**TOWN OF ESSEX PLANNING AND ZONING
SITE PLAN APPLICATION
BLACK BAY VENTURES V, LLC**

RESPONSE TO PUBLIC WORKS REVIEW COMMENTS

To: Dana Hanley, Community Development Director
Cc: Greg Duggan, Town Planner
Sharon Kelley, Town Zoning Administrator
From: Dennis E. Lutz, P.E., Public Works Director and Town Engineer
Aaron Martin, P.E., Town Engineer and Utility Director
Subject: Forestdale Industrial Park, 26 Thompson Drive
Black Bay Ventures (Site Plan Amendment)
Date: November 17, 2016

To: Dana Farley, Community Development Director
Cc: Greg Duggan, Town Planner
Sharon Kelley, Town Zoning Administrator
From: Dennis E. Lutz, P.E., Public Works Director and Town Engineer
Aaron Martin, P.E., Town Engineer and Utility Director
Subject: Forestdale Industrial Park, 26 Thompson Drive
Black Bay Ventures (Site Plan Amendment) <<< **Second Review**>>>
Date: November 30, 2016

SPRINKLER/WATER ENTRANCE DETAIL
SCALE: NONE

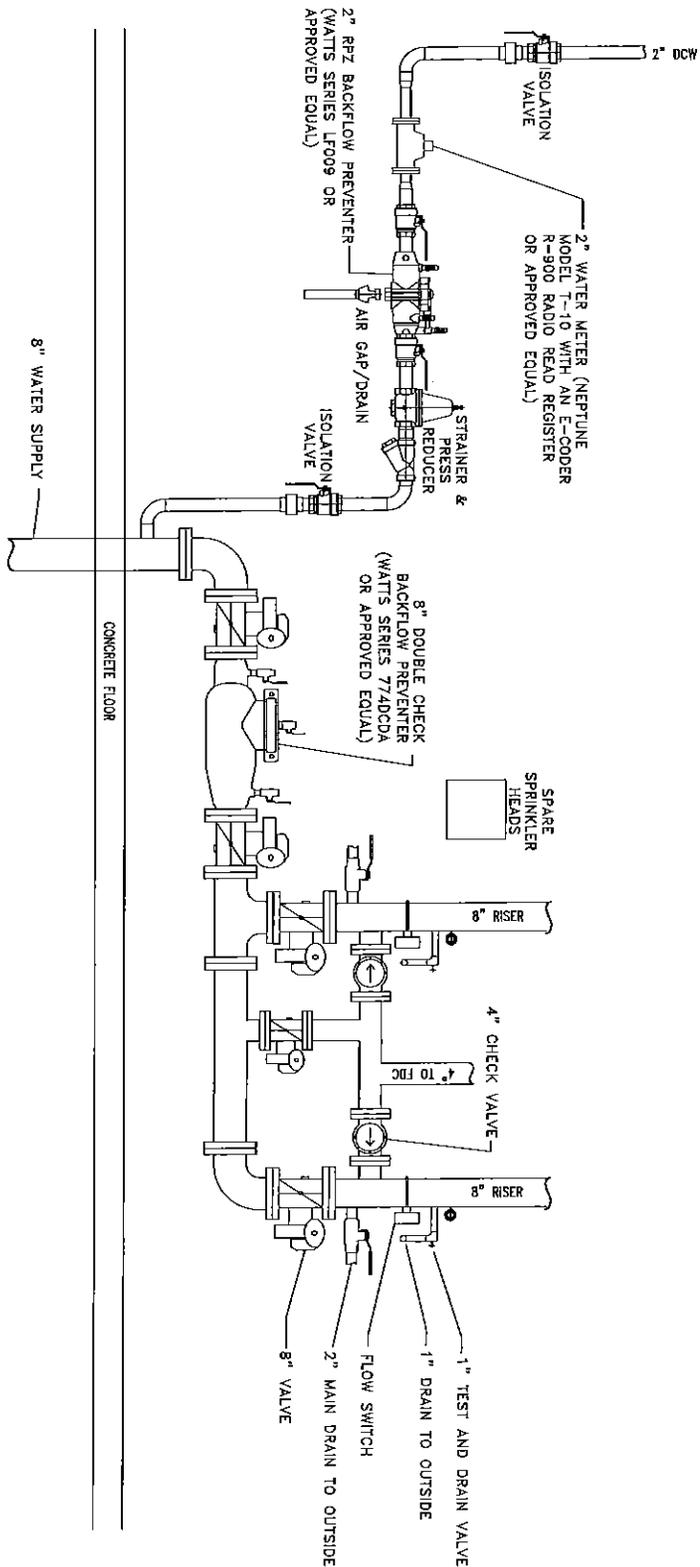
2. Subbase for sidewalks should extend 6" beyond the edge of the concrete sidewalk. (See VTrans Standards)
3. A Water / Sprinkler Connection detail should be provided. The detail should provide a gate valve or ball valve before and after the water meter on the domestic side of the service. A backflow prevention device shall be installed downstream from the meter and valves. Also, backflow prevention shall be provided on the fire suppression service.

Attached is a letter from the Building Fire Suppression Designer identifying the anticipated Fire Flow Demand of 1,426 gallons per minute. Also attached is a sketch illustrating the anticipated layout for the proposed building water supply entrance. As you have previously received the Traffic Evaluation, I believe that you have everything of which you have requested to this point. If you have any questions or require additional information, please call or email me as soon as possible.

3. The applicants engineer has provided fire flow demand calculations and a fire system connection detail of the internal plumbing for review. Public Works takes no exception
